Docket Number:	13-AFC-01C
Project Title:	Alamitos Energy Center - Compliance
TN #:	229735
Document Title:	Alamitos Energy Center Statement of Staff Approval of Proposed Change
Description:	N/A
Filer:	Joe Douglas
Organization:	California Energy Commission
Submitter Role:	Commission Staff
Submission Date:	9/13/2019 1:47:07 PM
Docketed Date:	9/13/2019

STATEMENT OF STAFF APPROVAL OF PROPOSED CHANGE

ALAMITOS ENERGY CENTER (13-AFC-01C)

STAFF ANALYSIS
ALAMITOS ENERGY CENTER (13-AFC-1C)
Petition to Amend the Final Commission Decision
AIR QUALITY
Nancy Fletcher

**Environmental Justice – Table 1
 Low Income Data within the Project Area**

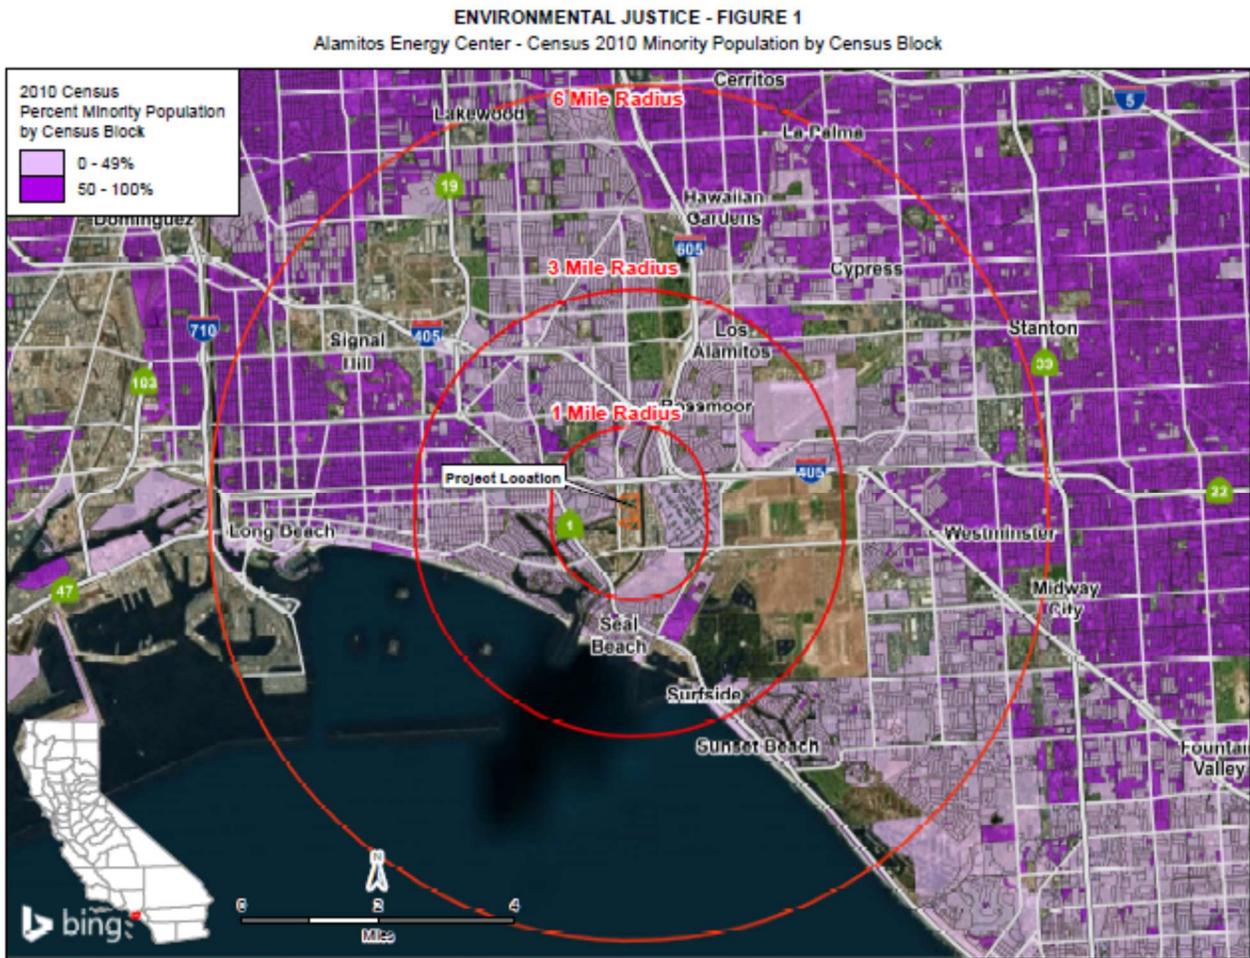
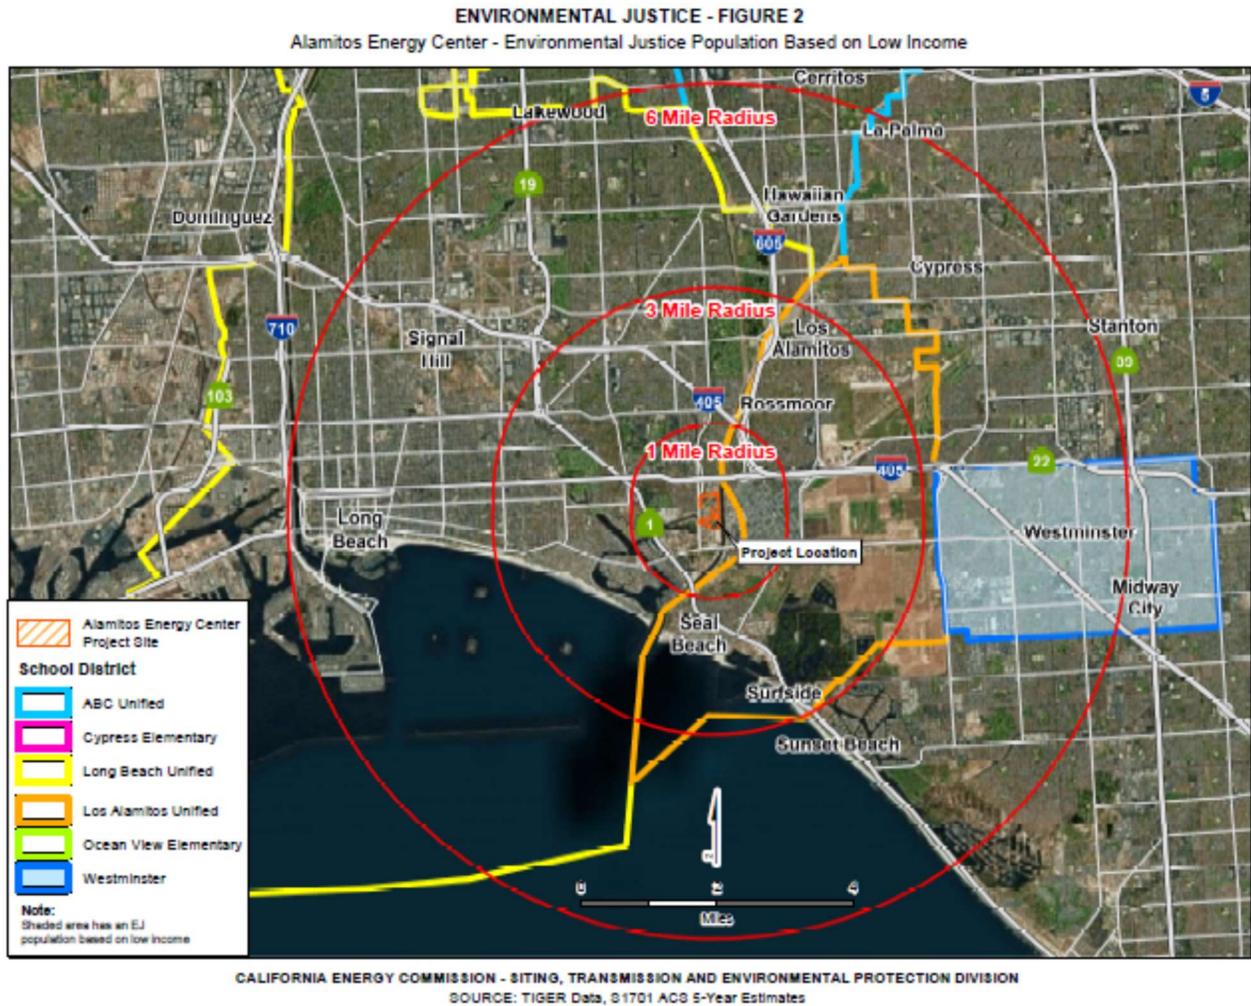
The **Environmental Justice – Figure 1** shows 2010 census blocks in the six-mile radius of AEC contain a minority population greater than or equal to 50 percent. The population in these census blocks represents an EJ population based on race and ethnicity as defined in the United States Environmental Protection Agency’s *Guidance on Considering Environmental Justice During the Development of Regulatory Actions*.

Based on California Department of Education data in the **Environmental Justice – Table 1**, staff concluded that the percentage of those living in the school district of Westminster Elementary School District (in a six-mile radius of the project site) and enrolled in the free or reduced price meal program is larger than those in the reference geographies, and thus are considered an EJ population based on low income as defined in *Guidance on Considering Environmental Justice During the Development of Regulatory Actions*.

Environmental Justice – Figure 2 shows where the boundaries of the school districts are in relation to the six-mile radius around the AEC site.

Staff determined the project change would not affect the technical areas listed above except Air Quality. For Air Quality, staff concluded impacts would be less than significant with implementation of the proposed and existing conditions of certification in the Final Decision. Therefore, impacts would be less than significant for any population in the project's six-mile radius, including the EJ population represented in **Environmental Justice - Figures 1 and 2, and Table 1.**
